- **CLIMATE CONTROL—RATTLE NOISE FROM INSTRUMENT PANEL VENTS—DIFFICULT TO ADJUST**
- **NOISE—CLIMATE CONTROL—RATTLE NOISE FROM INSTRUMENT PANEL VENTS—DIFFICULT TO ADJUST**

**Article No.
04-5-3**

FORD: 2001-2004 MUSTANG

Figure 1 - Article 04-5-3

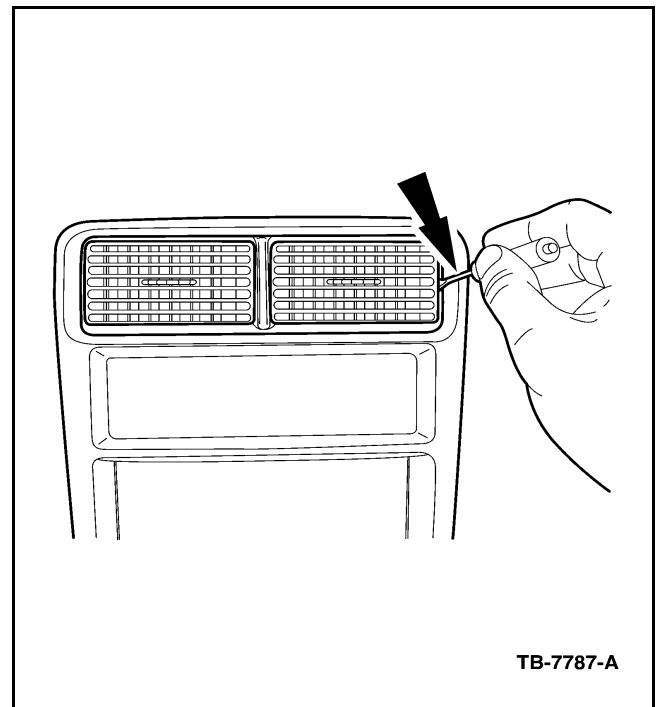
1. Order replacement vent (3R3Z-19893-AB), one (1) for each vent requiring replacement.
2. Remove the vent by prying it away with a flat screwdriver (Figure 1).
3. Install the revised vent by pressing the new vent into place (Figure 2).
4. Repeat Steps 1-3 as needed.
